PLAN COMMISSION STAFF REPORT

Agenda Item: PC Docket No. 23-010

Application: **Zoning Amendment – Planned Unit Development Amendment**

Summary: Maple Leaf Crossing LLC requesting approval of an amendment to the Maple Leaf Crossing Planned Unit Development to add parking spaces and modify Lots 2-7 and Outlots A and B.

SHEET
C-2.0

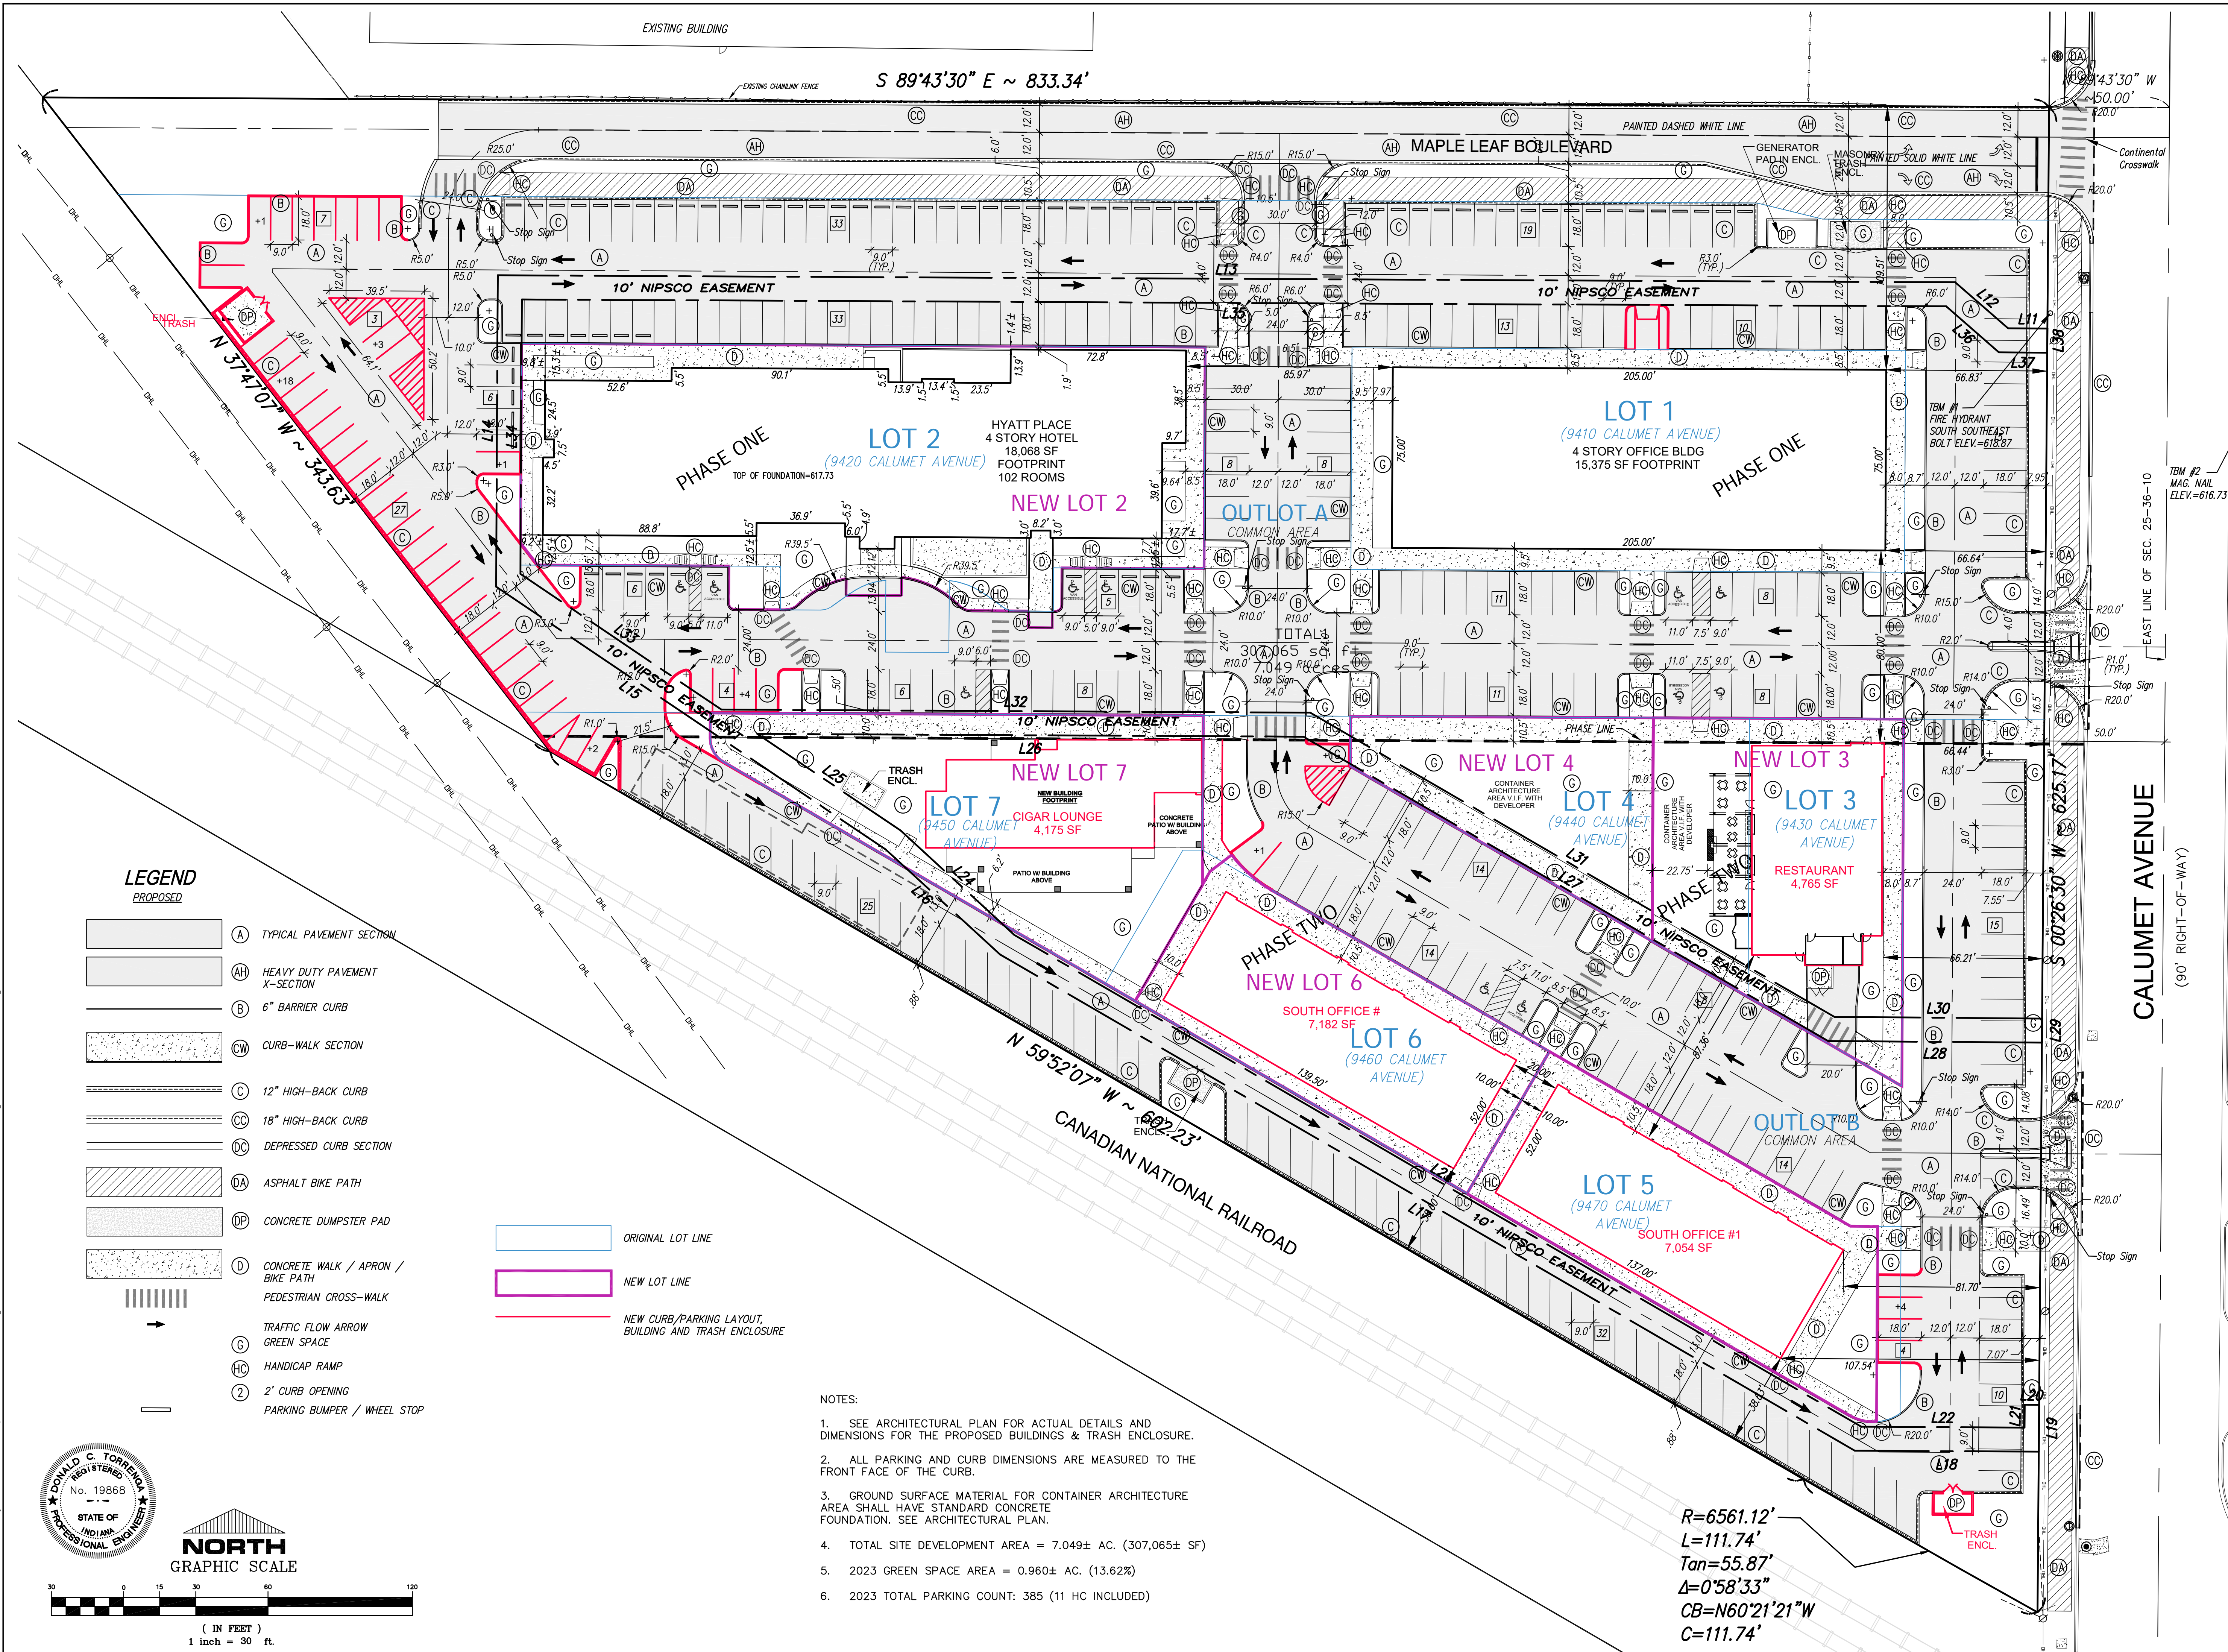
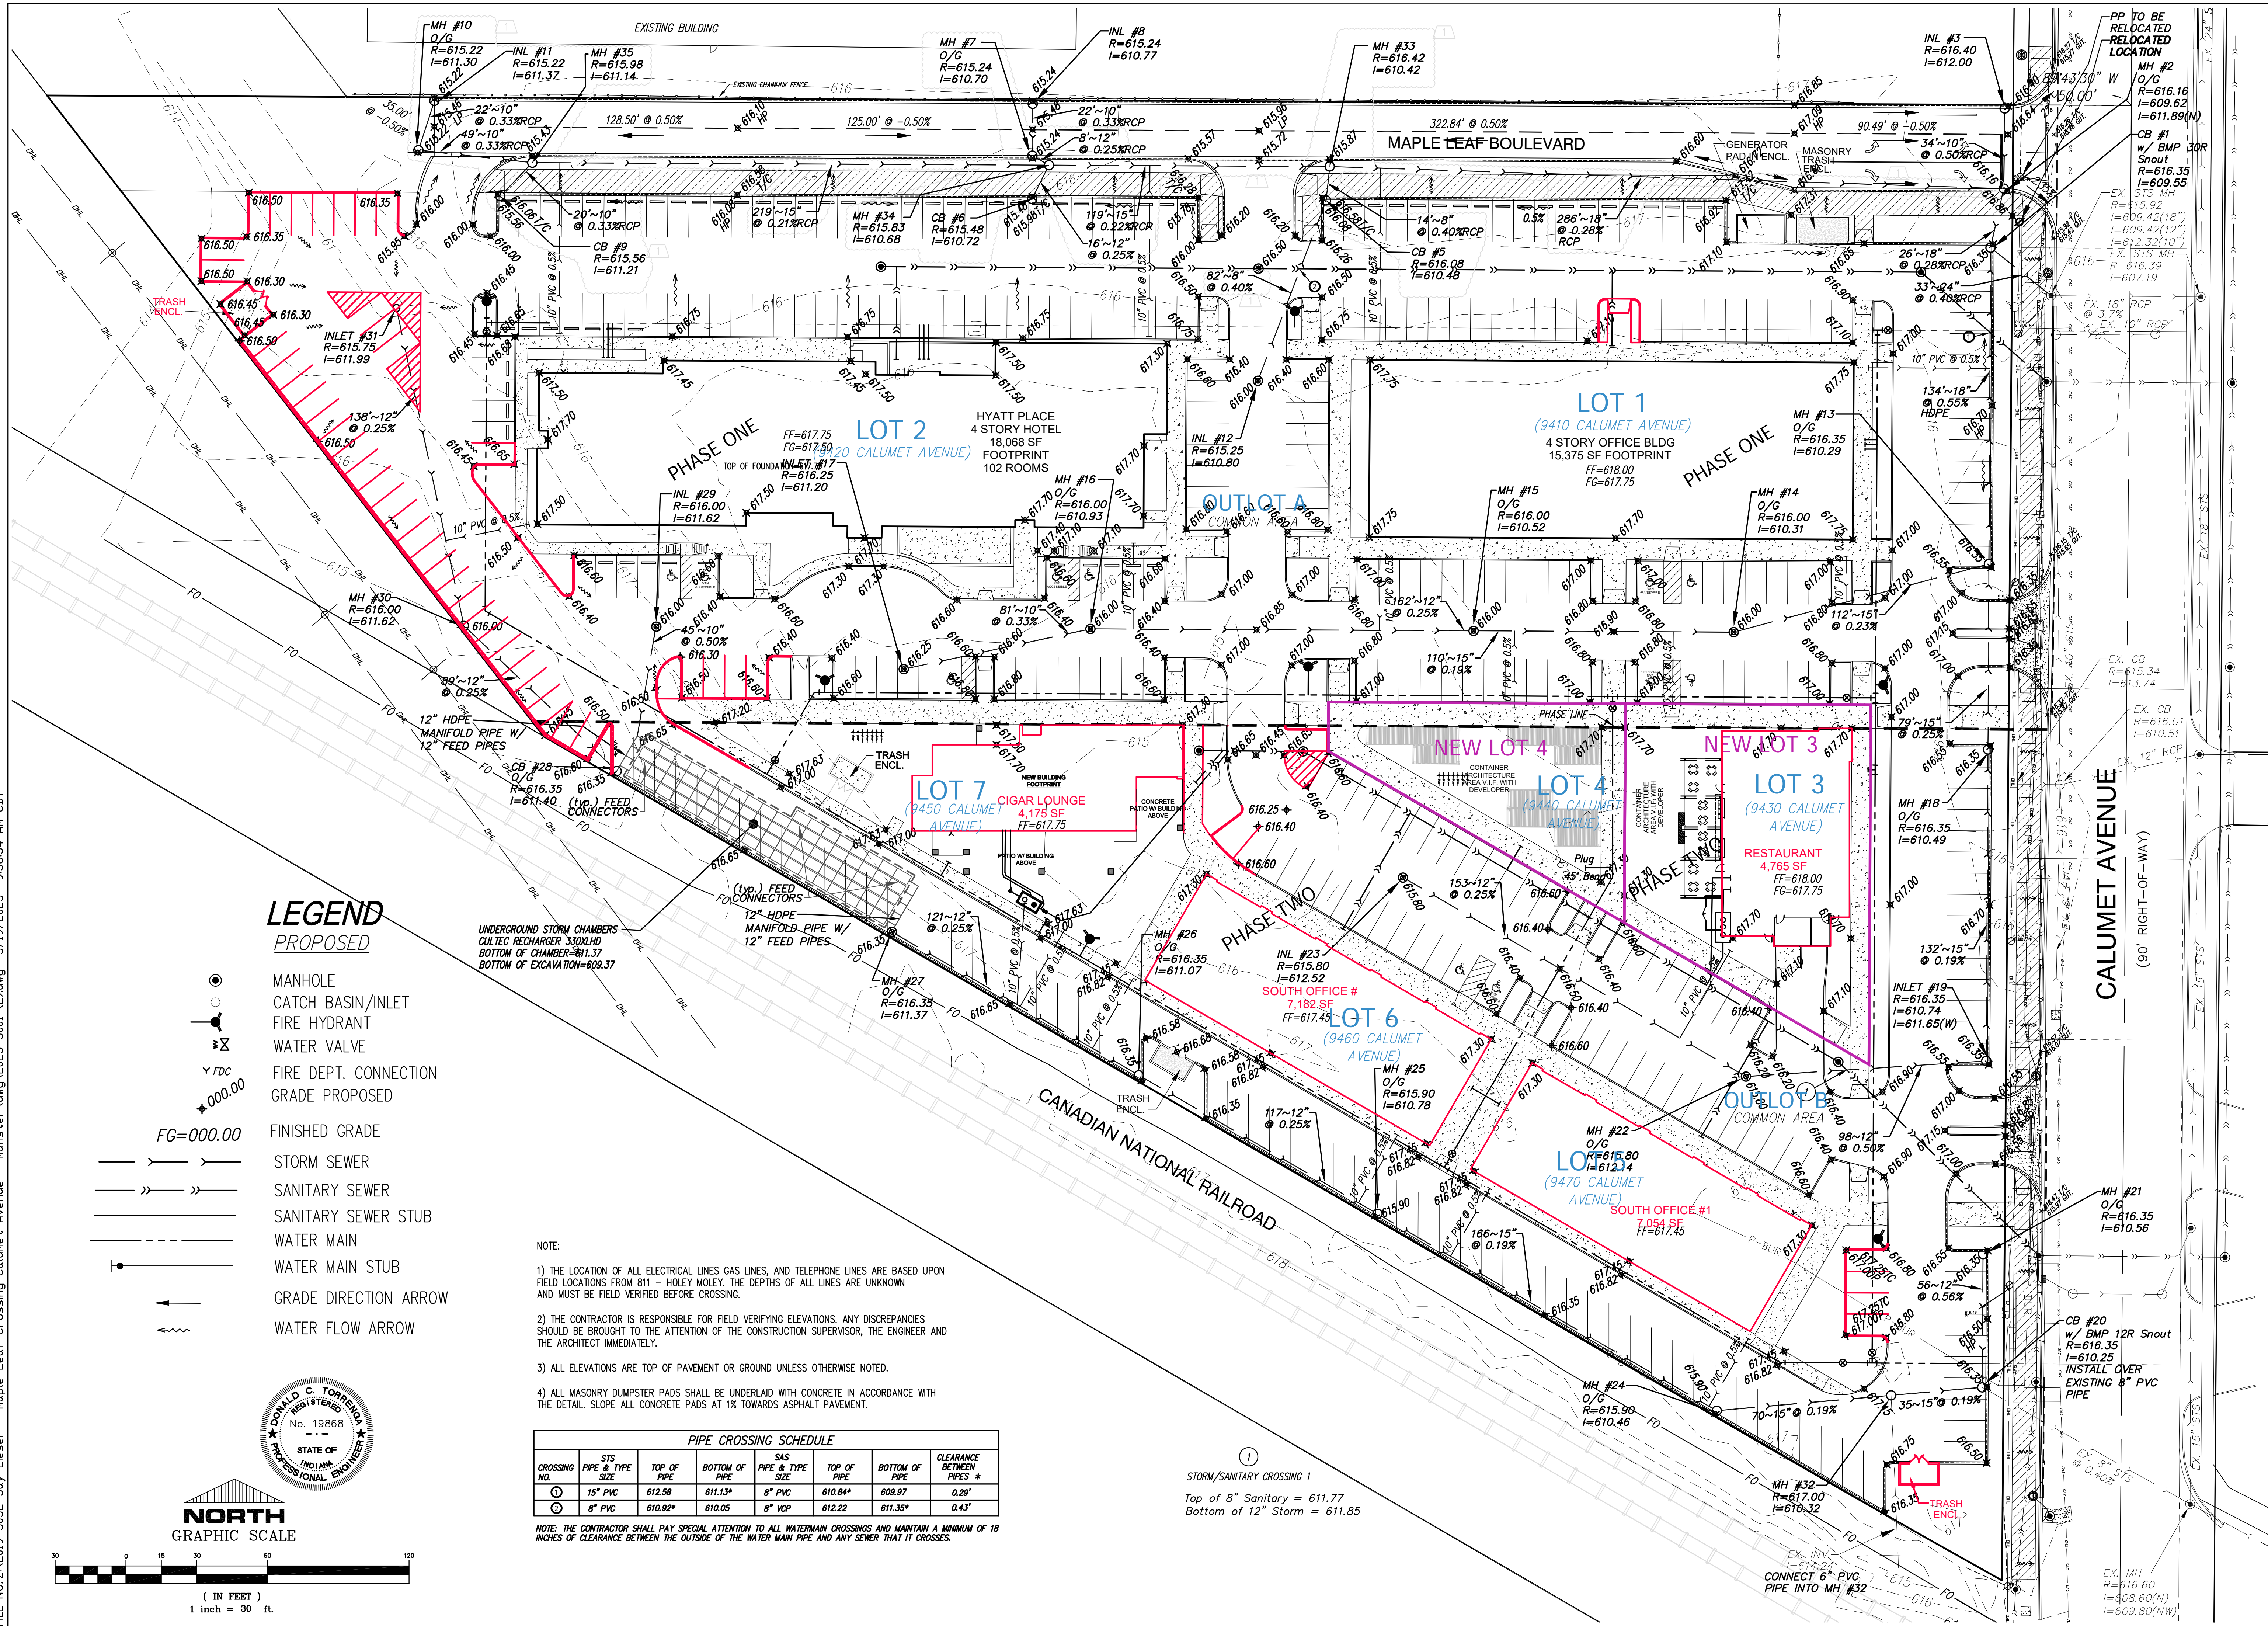
On Lot 7, the proposed plans indicate a change in the building square footage of the cigar bar and restaurant. An email dated 5/31/2023 from Jay Lieser indicates that the square footage on the drawings indicates the square footage of the first floor of the structure. This is not consistent with the way other structures are labeled on the site plan, as the square footage indicated on the other structures is the total square footage of the structure, not just the first-floor square footage.

8.	Pedestrian and Bicycle Access Sidewalks and bicycle paths shall be located within and upon Maple Leaf Crossing as set forth in the Approved Development Plan	The bicycle path through the Maple Leaf Crossing PUD has been removed. A bicycle path remains in the Maple Leaf Boulevard right-of-way.	Needs Plan Commission Determination

V.	Landscape Design Criteria Landscaping for Maple Leaf Crossing shall generally be in accordance with the Landscaping Plan attached hereto as Exhibit C and incorporated herein.	Landscaping has been decreased to accommodate additional hardscape for parking.	Needs Plan Commission Determination**

However, staff is concerned with the increase in hardscape and the decrease in landscaped areas in the petitioner's proposed plans. Since the petitioner has not provided new evidence or data that additional parking spaces are needed for the approved uses at Maple Leaf Crossing, the need to replace landscaping with parking spaces is not clear. According to the Munster Zoning Ordinance, landscaping for parking lots should follow Section 26-6.405.O.1.h.vii.l. Key parts of this section of the code include the following:

- A commitment to plant future parkway trees after construction of the Maple Leaf Boulevard Extension in the right-of-way labeled "No Plantings in Right-of-Way."
- The removal of 3 proposed parking spaces to be replaced with landscaping in the far northwest corner of the site.
- The removal of 1 parking space southeast of the trash enclosure to be replaced with a landscape island in the northwest corner of the site.
- The removal of 3 parking spaces just west of the NIPSCO easement in the northwest corner of the site to be replaced with a landscape island per approved development plan (see Section 26-6.405.O.1.h.vii.I.5).
- The removal of 1 parking space west of the NIPSCO easement in the northwest corner of the site to be replaced with a landscape island (see Section 26-6.405.O.1.h.vii.I.1).

With these modifications, the proposed parking of the site would be decreased by eight (8) spaces, for a total of 377 parking spaces, which is still a 7.1% increase in parking from the approved development plan per Ordinance 1879. See image on next page for more details.

Staff also recommends the crosswalk in Outlot A between Lot 2 (Hyatt) and Lot 7 (cigar bar and restaurant) be redesigned to be perpendicular with the drive lane. Crosswalks that are perpendicular to cross the street (or drive lane in this case) are shorter and help to move pedestrians through a street or drive lane more quickly. See image on next page for more details.

Staff recommends that on the Development Plan, the square footage of the structure proposed for Lot 7 to be updated to reflect the total square footage of the structure (6,400 square feet), rather than the square footage of the first floor of the structure (4,175 square feet). The square footage of the other structures on the site are labeled by total square footage of the structure, so this change will ensure the information displayed on the plan is consistent between structures.

- *Modifications to the parking areas on the Development Plan that reflect no more than 377 parking spaces in Outlots A and B. These modifications include the following:*

- o *The removal of 3 proposed parking spaces to be replaced with landscaping in the far northwest corner of the site.*
 - o *The removal of 1 parking space southeast of the trash enclosure to be replaced with a landscape island in the northwest corner of the site.*

- o *The removal of 3 parking spaces just west of the NIPSCO easement in the northwest corner of the site to be replaced with a landscape island as originally approved.*

- o *The removal of 1 parking space west of the NIPSCO easement in the northwest corner of the site to be replaced with a landscape island.*
- *A modification to the Development Plan to show the crosswalk in Outlot A between Lot 2 and Lot 7 to be redesigned to be perpendicular to the drive lane.*

- *A modification to the Development Plan to show the square footage of Lot 7 to be updated to the total square footage of the structure (6,400 SF) to be consistent with the square footage labeling of other structures on the Development Plan.*
